Enclosure 3
March 2009 Meeting Handouts
Meeting Summary of the 03/19/09 Reactor Oversight
Process Working Group Public Meeting
Dated April 10, 2009

Industry Proposed Resolution of PMT – Available/Operable Issue

NRC MSPI White Paper

Proposed Change to Risk Cap

Figure 1: Available / Not Operable

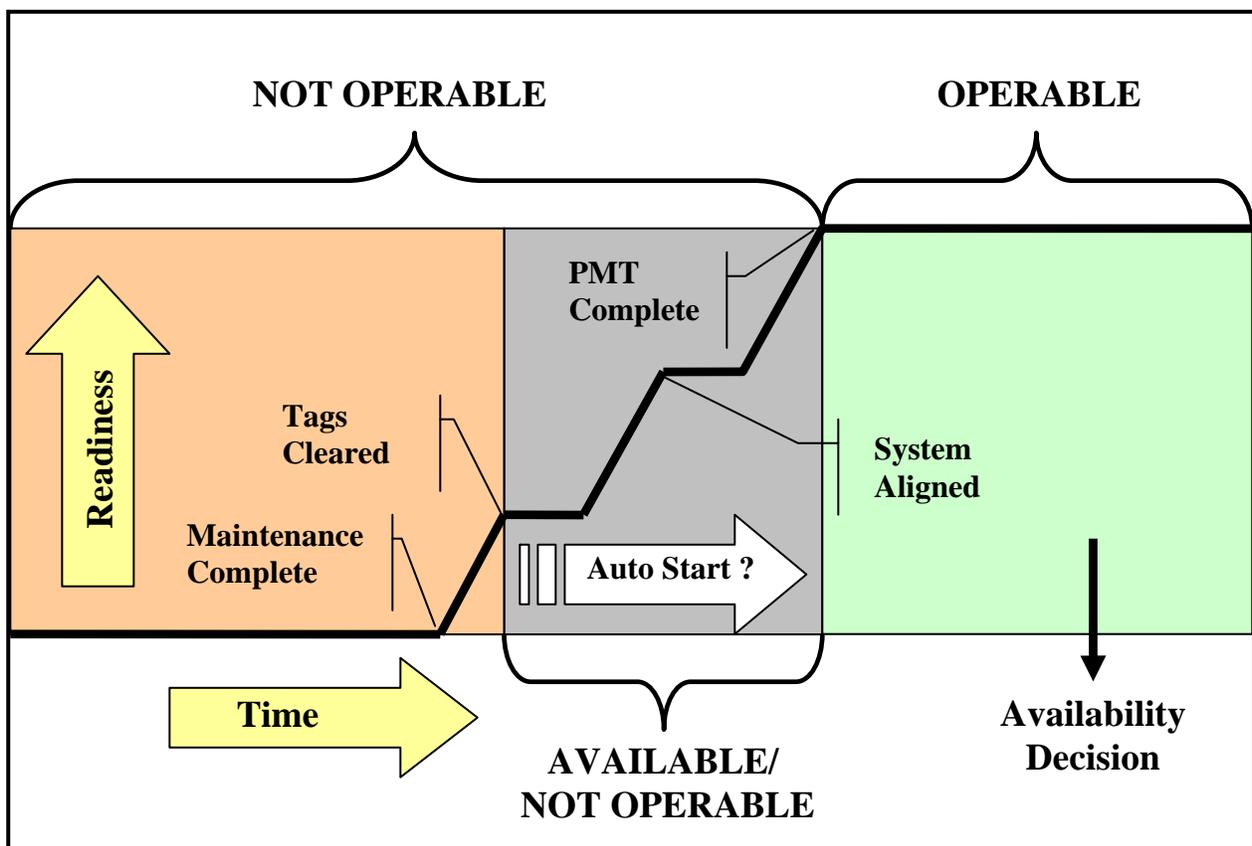
An industry practice (used by some licensees for some equipment) is to consider equipment potentially “available,” upon completion of maintenance but prior to the performance of the post maintenance test (PMT). This determination of availability is typically performed independent of operations personnel, and is made after the completion of the PMT. If the equipment passes its PMT, the status of the equipment between the completion of maintenance and the PMT is scored for MSPI purposes as “available.” If the equipment fails its PMT, the status of the equipment between the completion of the maintenance and the PMT is “unavailable.” This practice is illustrated in Figure 1.

The staff's concern with this approach is:

- Lack of clear guidance
- Potential for limited operator awareness
- Potential for non-conservative treatment of equipment reliability
- Potential for regulatory inconsistency

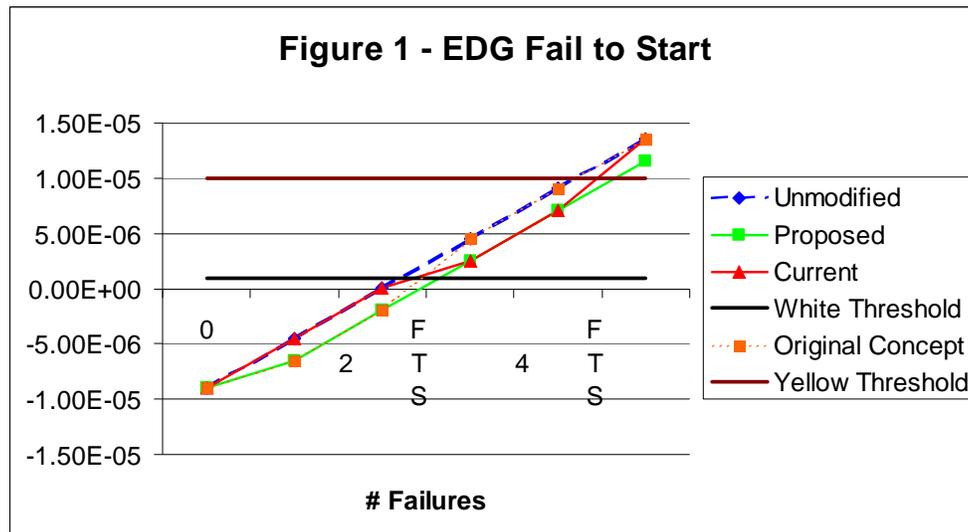
Figure 1 shows the impact of each additional EDG failure to start. It should be noted that both the current and proposed risk cap treatment results in the same MSPI color regardless of the number of failures.

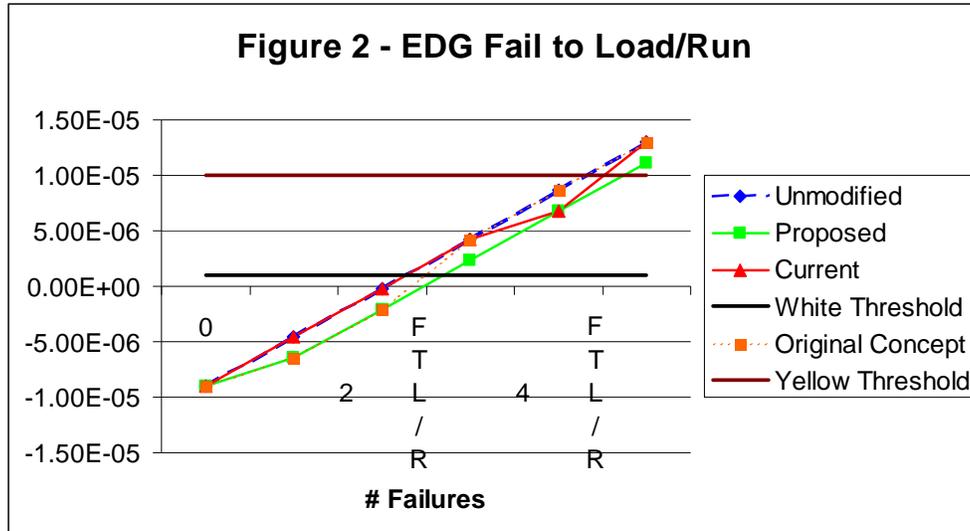
Figure2 shows the impact of each additional EDG failure to load/run. As with failures to start, both the current and proposed risk cap treatment results in the same MSPI color regardless of the number of failures.

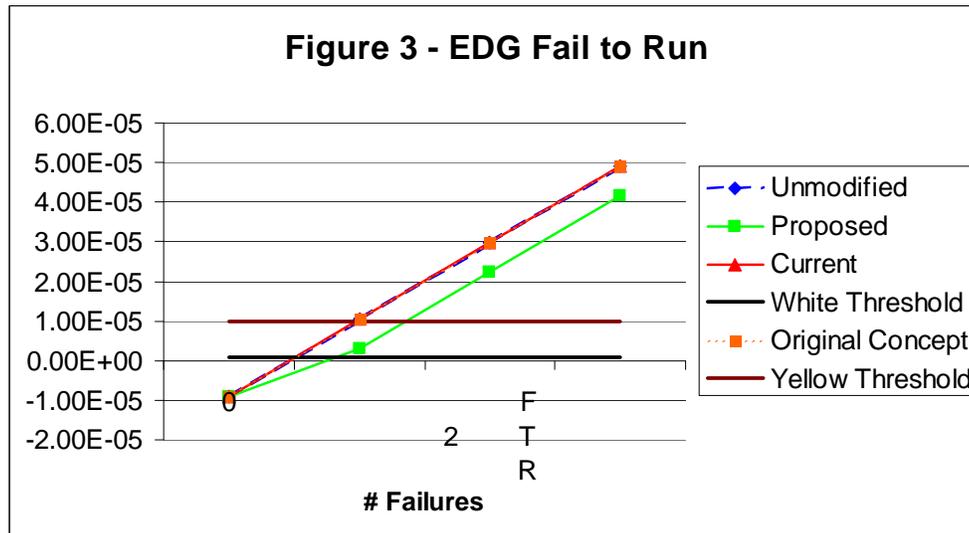
Figure 3 shows the impact of each additional EDG failure to run. The primary difference between the current Risk Cap and the proposed Risk Cap is that under the current risk cap, a single failure (with the included contribution from unavailability) results in a Yellow MSPI, while under the proposed change to the Risk Cap, this results in a White Configuration. A second failure results in a Yellow MSPI from both approaches.

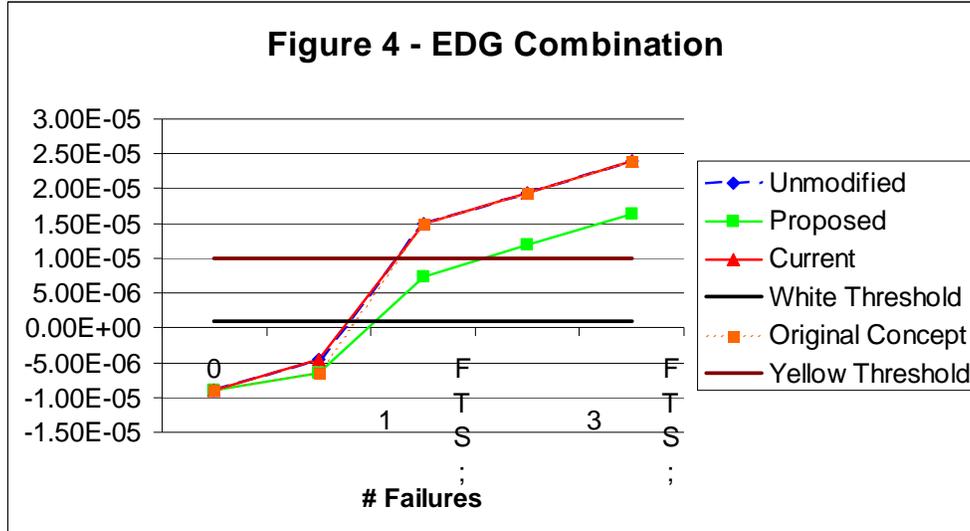
Figure 4 shows the impact of from different failure modes. The first failure is assumed to be a failure to start, followed by a failure to run then additional failures to start. Under the current Risk Cap treatment, the MSPI jumps from Green to Yellow following the failure to run, even though neither failure may be statistically significant. The proposed Risk Cap change results in a smoother transition (Green, White, Yellow) as additional failures are added.

Example 2: NUREG-1816, Case 1

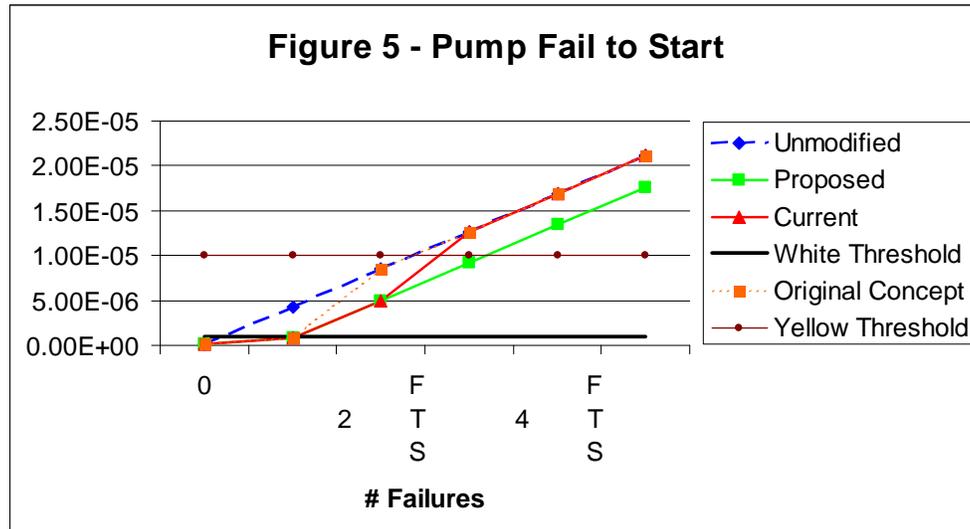
For this example, a plant experiences a start failure of an Auxiliary Feedwater motor-driven pump. Prior to the failure, the $UAI = 1 \times 10^{-7}$. The delta URI associated with the start failure is 4×10^{-6} . No other failures have occurred during this reporting period yielding an URI baseline of zero (this is a simplification since baseline could be below zero). The UAI contribution resulting from the repair unavailability is 2×10^{-7} . For this scenario, both the current Risk Cap and proposed change result in exceeding the White Threshold after the 2nd failure. However, it does require 1 additional failure (4 failures versus 3 failures) to exceed the Yellow threshold under the proposed change to the Cap (See Figure 5).

Example 3 – Essential Service Water Pump Failure to Run

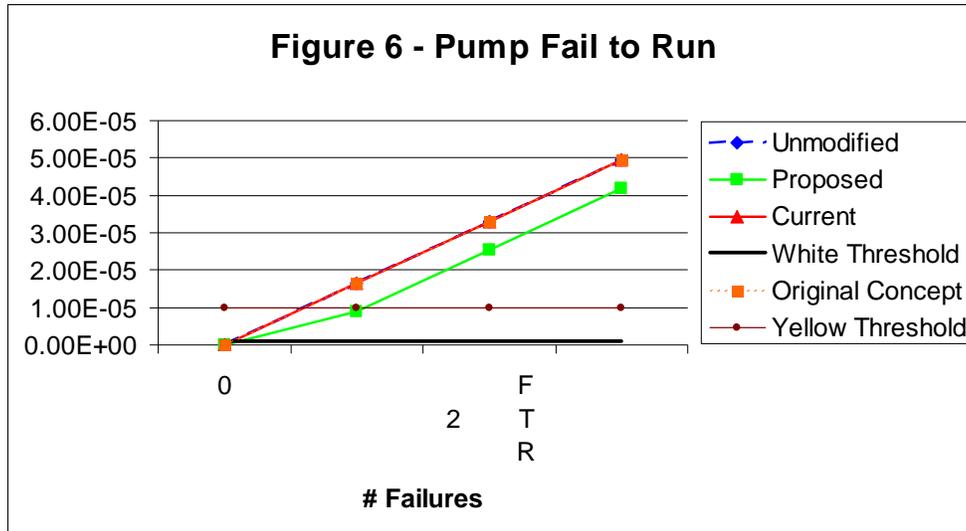
A plant has a URI with no failures of -4.50×10^{-6} . The MSPI value is -4.2×10^{-6} with a UAI of 2.7×10^{-7} . (Note that there are 2 pump failures in the other CWS, each with a URI

For this plant, a single failure to run results in a Yellow MSPI under the current Risk Cap. With the proposed Risk Cap, the MSPI is White following a single Failure to Run and Yellow after the second failure (See Figure 6).

Example 4 – Increasing UA

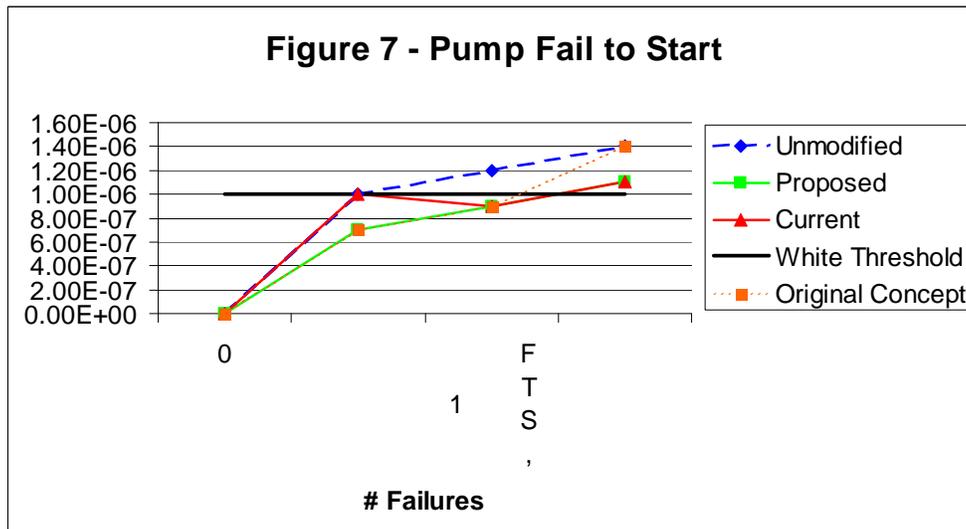
For this example, it is assumed that the MSPI is at 0 and that a Failure to Start has a URI contribution of $8E-7$. Following the first failure, the UA contribution is increase in $2E-7$ increments. As can be seen in Figure 7, since the current Risk Cap is only applied once the MSPI exceeds $1E-6$, increases in UAI can result in a decrease to the MSPI value. The revised Risk Cap eliminates this discrepancy.
